FARRAGUT MUNICIPAL PLANNING COMMISSION

May 18, 2023

SUBJECT: Discussion and public hearing on a site plan for the Knoxville Tennessee Temple, 13001 Kingston Pike, Zoned C-1, 5.26 Acres (Moody Nolan, Applicant)

Re: Staff Comments on the Site Plan for the Knoxville Tennessee Temple, Parcel 068,
Tax Map 151, 13001 Kingston Pike

TYPE OB1

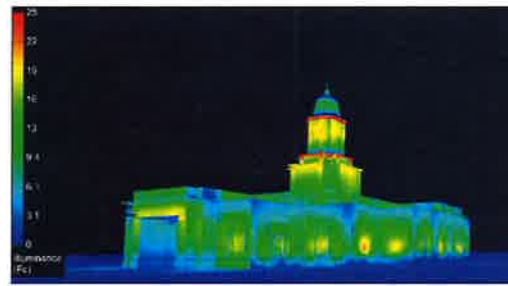
- iii. c.A diagram showing the overall height and fixture orientation of pole mounted lights. If old poles are to be reused with new fixtures, the lighting plan shall certify that the old poles will meet the EPA ratings required to support the new fixtures.

BARN DOORS TO SHIELD LIGHT ON ROOF LIGHT FIXTURES TO ONLY SHINE ON TEMPLE WALLS

Lights have been located and detailed in the sealed lighting plans.
